Service Bulletin

101 East Seneca Bancroft, IA 50517	Bulletin #: 100715	Date: 10-07-15
Prepared by: Bob Mortenson	Phone # 515-885-2398	Page: 1

Inform Aluma dealers and owners that 5410T tilt trailer may have missing weld that may contribute to a failure of the trailer’s tongue weldment.

Figure 1

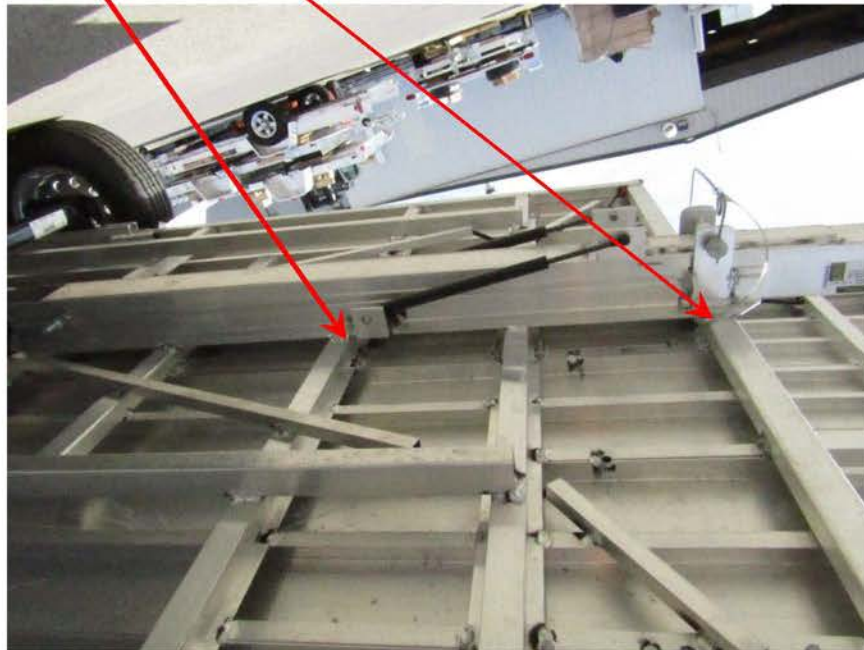
- 2.0 Inspect all welds and base material on tongue retainer and trailer frame to ensure no signs of damage has occurred. See Figure 1, 2 and 3. Prepare surface areas that are to be welded. Person performing retrofit should be qualified and proficient aluminum welder. **Caution:** Use appropriate PPEs when preparing surface and welding.

Inspect weld and base material

Figure 3

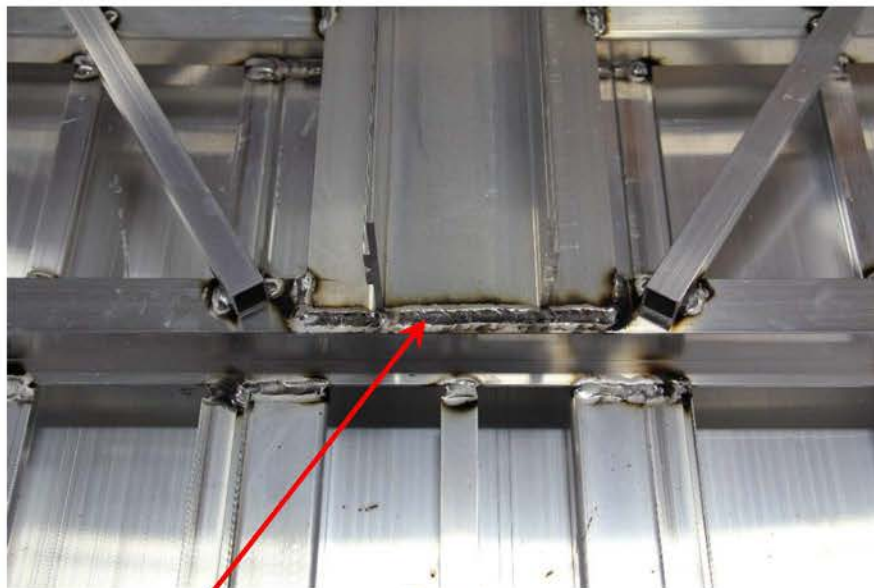
Inspect weld and base material

Figure 5

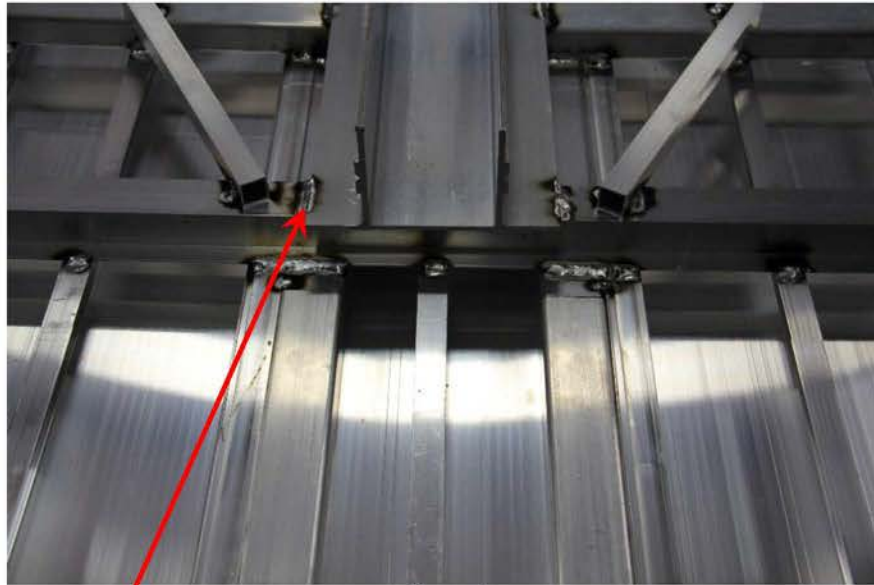
- 3.0 Figures 4 and 5 shows different orientation of tongue retainer. If welds are missing, then add .25” fillet welds as shown See Figure 4 and 5. **Note:** Ensure that wiring harness is not damaged during welding.

If weld is missing add .25" fillet welds as shown

Figure 7

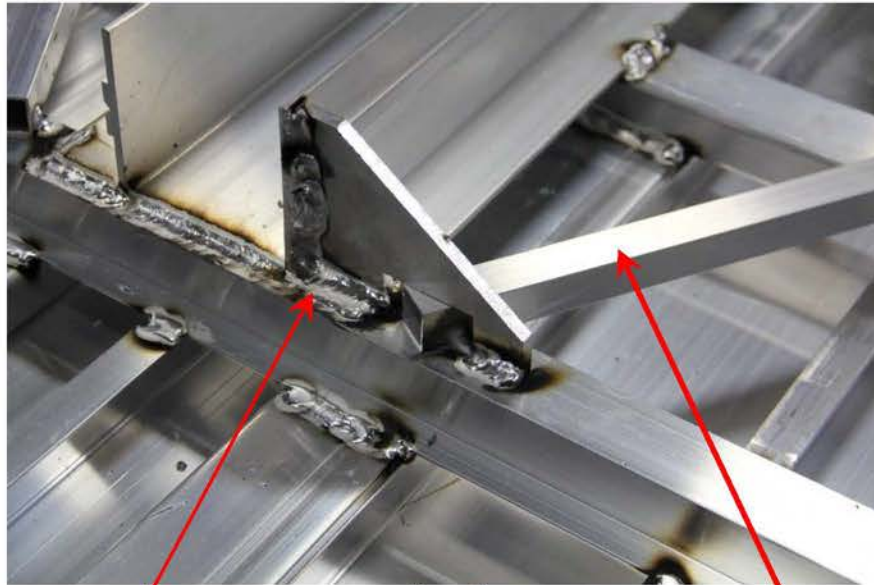
- 4.0 Add 2 gussets and .25” fillet weld as shown in Figure 6 and 7.
- 5.0 Verify work has been completed and all tools and hardware is secured. Raise trailer and remove jack stands.

Add 2 gussets and .25" fillet welds as shown. One gusset on each side of tongue retainer.

Adjustment of wire tubes maybe necessary for proper gusset orientation.
